MOBILETT Plus HP

Repair Instruction

Replacement of the inverter

Kit part No. 65 53 981

Fig. 4

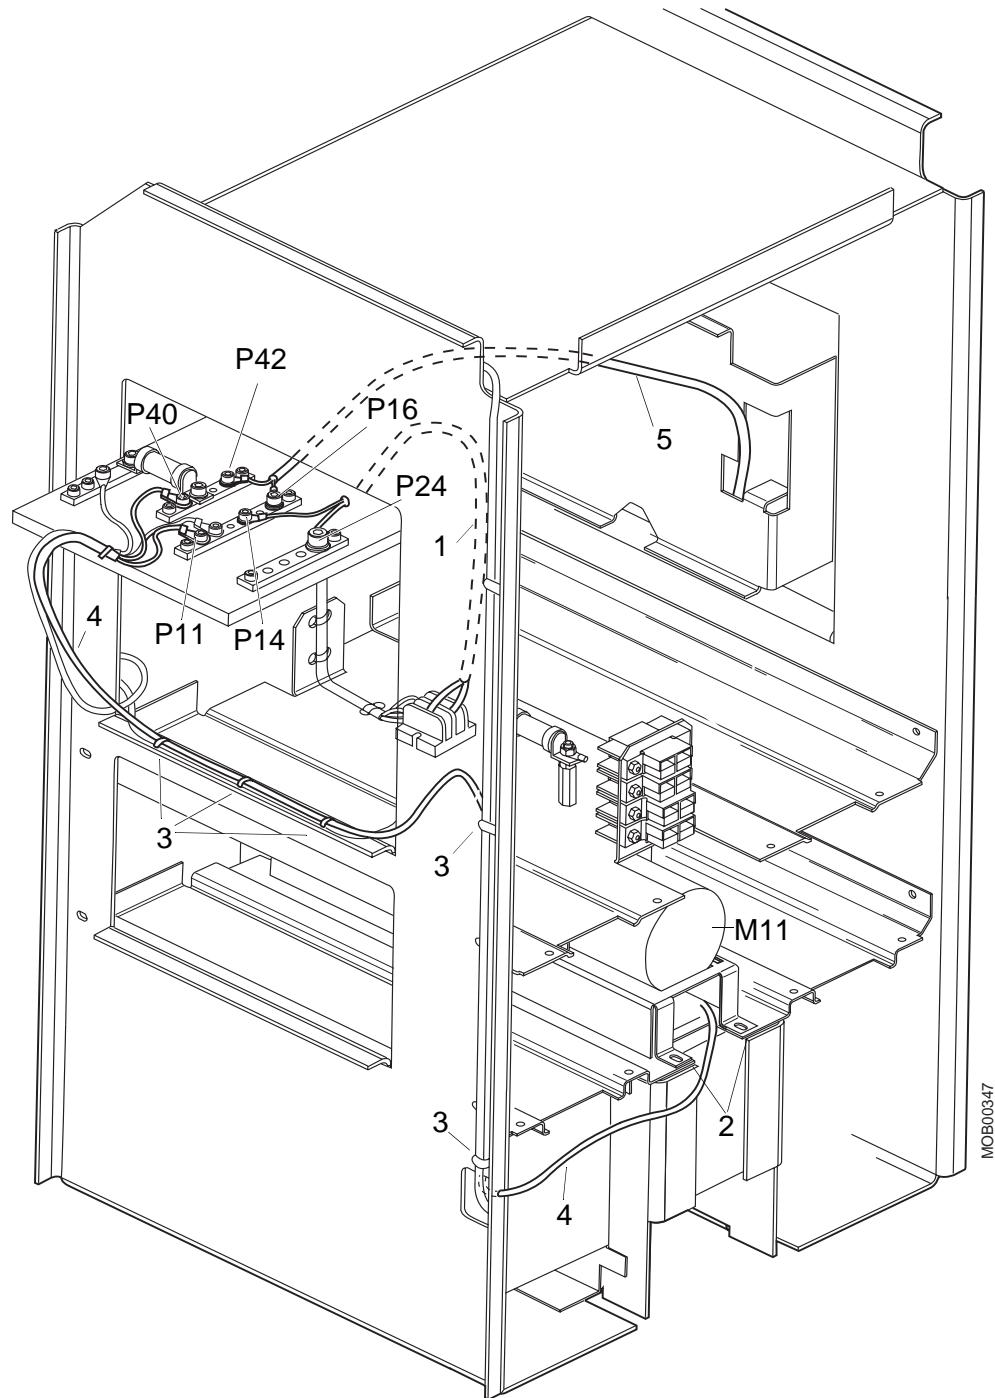
2. Disconnect cable (1/Fig. 4) from P24 and P14 on the power conversion unit.

- Insert the capacitor unit, M11, and fasten it with screws (2/Fig. 4).
- Cut cable ties (3/Fig. 4). Connect the cable (4/Fig. 4) to P11 and P40 according to Fig. 4. Fasten with new cable ties.
- Disconnect cables K8 and K64 on the right-hand side and replace the inverter. Connect cable (5/Fig. 4) to P16 and P42 on the power conversion unit.
- The PROMs in position I72, I66 and I74 are found on board D1 under the top cover. Replace each PROM with a new PROM marked with the same letters.

Fig. 5

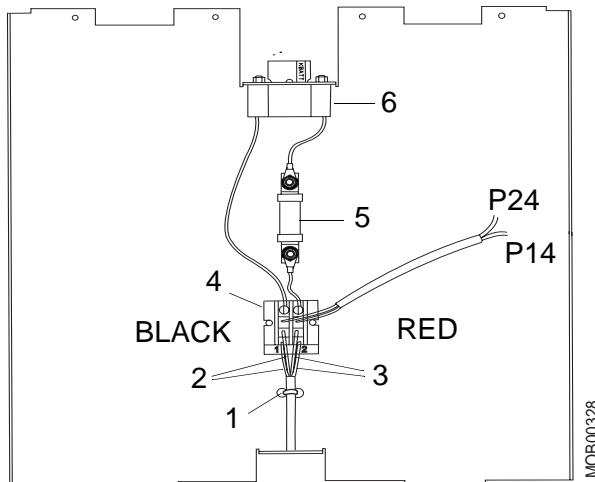
- Cut the cable ties on the upper shelf (1/Fig. 5). Disconnect black cables (2/Fig. 5) and red cables (3/Fig. 5) from the connector (4/Fig. 5).

- Remove the upper and lower battery shelves from the MOBILETT Plus HP by loosen four screws on each side.
- Move the fuse (5/Fig. 5), connector (4/Fig. 5) and battery connector (KBATT) (6/Fig. 5) from the old upper battery shelf to the new upper shelf.
- Insert the new battery shelves and fasten them tight with screws. The heads of the screws must be on the inside of the chassis.
- Connect cable (1/Fig. 4) to P14 and P24 on the power conversion unit.
-

Be sure to connect the red and black cables right (see Fig. 5) otherwise the power conversion unit could be damaged.

Connect the black (2/Fig. 5) and red cables (3/Fig. 5) to the connector on the upper battery shelf and fasten with new cable ties.

X037E

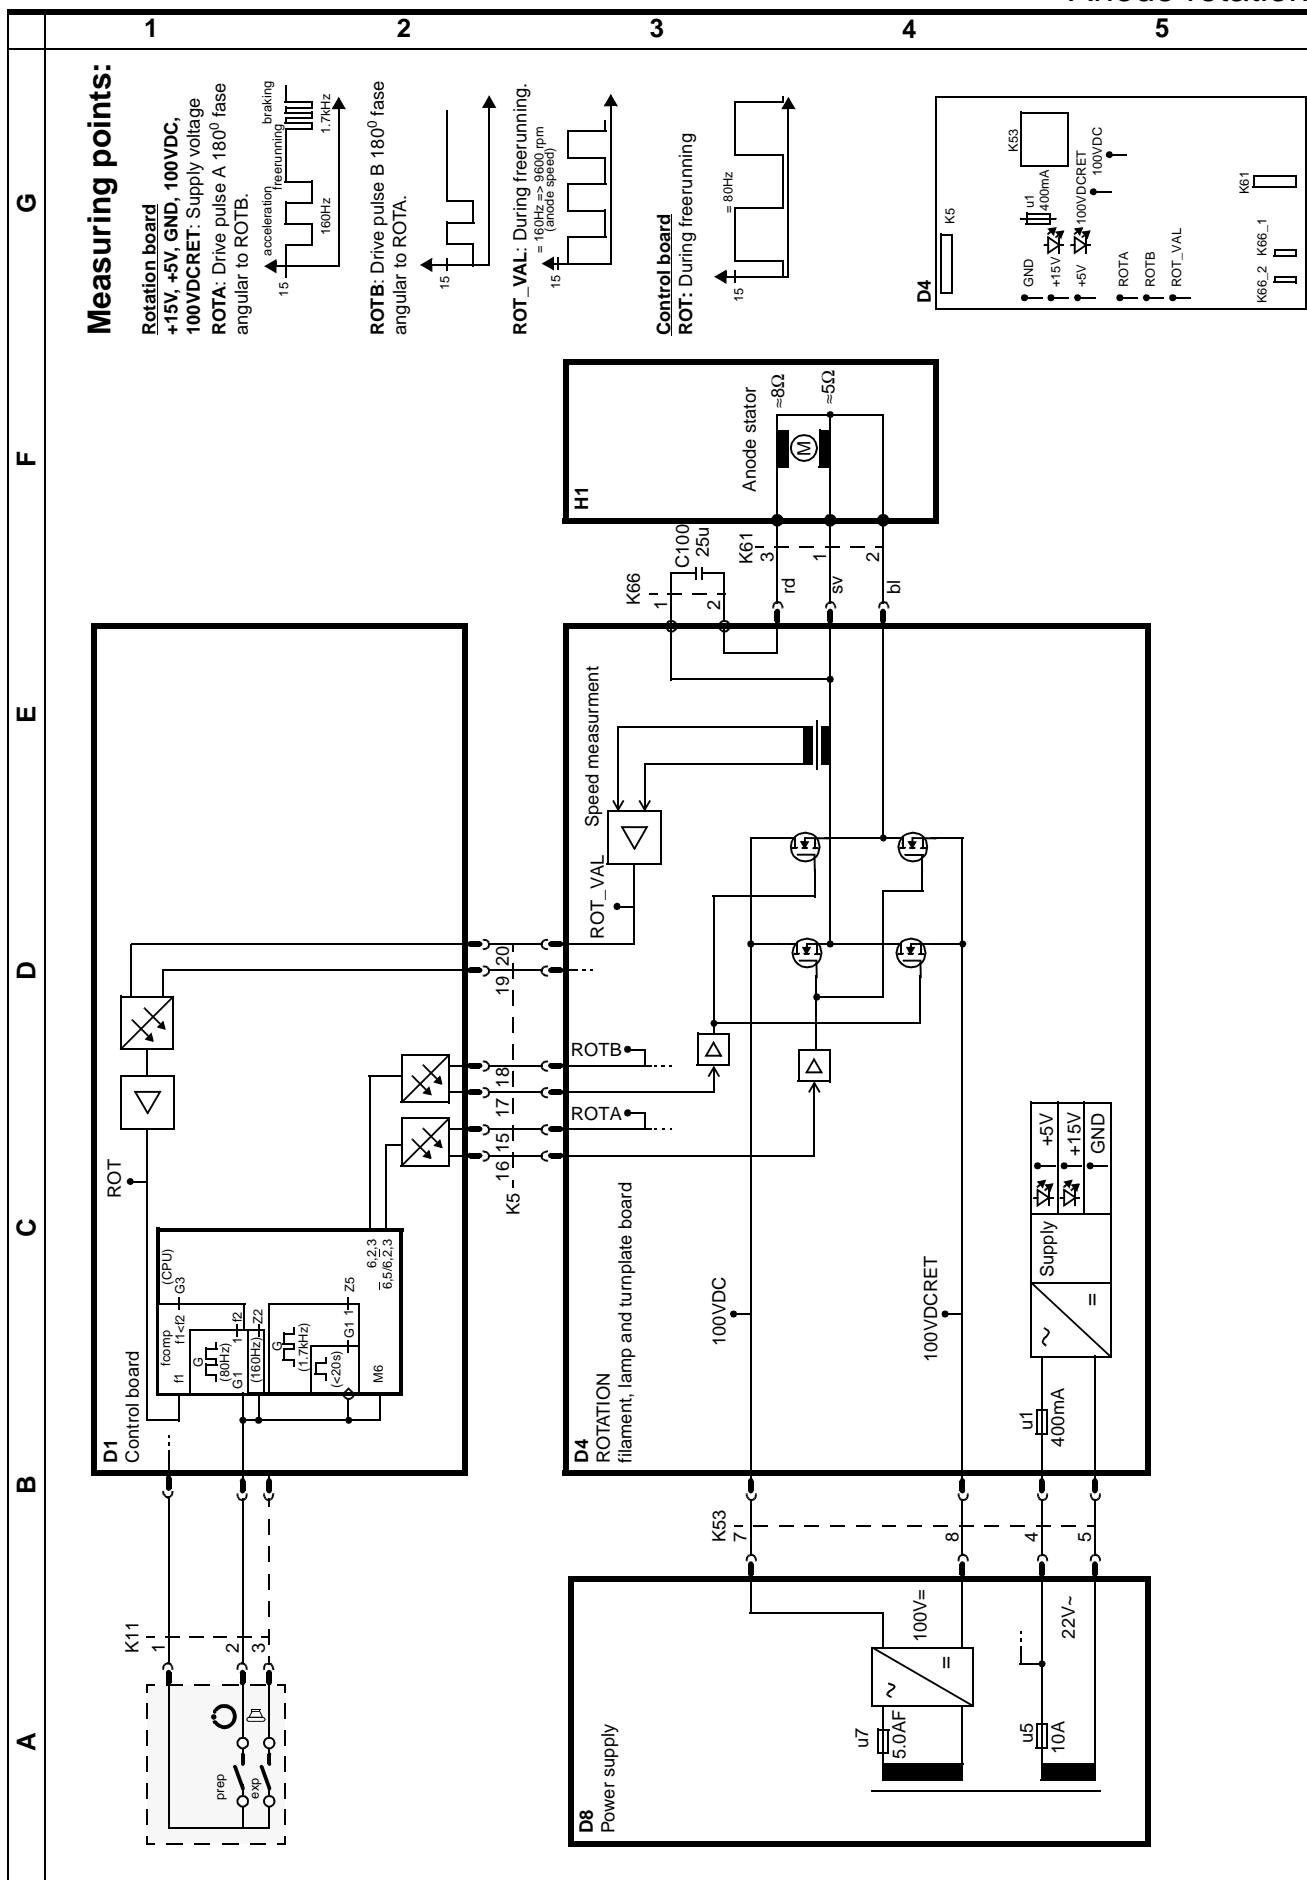
- Max preparation time is increased from 10 s to 20 s.
- The service programs P05 (Automatic maintenance test), P12 (Inverter and single tank test) and P13 (Inverter test) are removed.
- **Only for MOBILETT Plus HP** - The service program P11 (Backup battery test) is removed.

Accelerates the anode with a 160 Hz control signal during two seconds. After this first acceleration, the speed is measured and if necessary, a second acceleration of two seconds is performed. When the correct speed is reached, the anode will rotate freely for 20 seconds or until the rotation frequency is below 142 Hz before it is braked during 9 seconds to a stop. An error message will be displayed after two unsuccessful attempts to accelerate the anode or if the anode loses speed too fast. When the test is activated, the display shows:
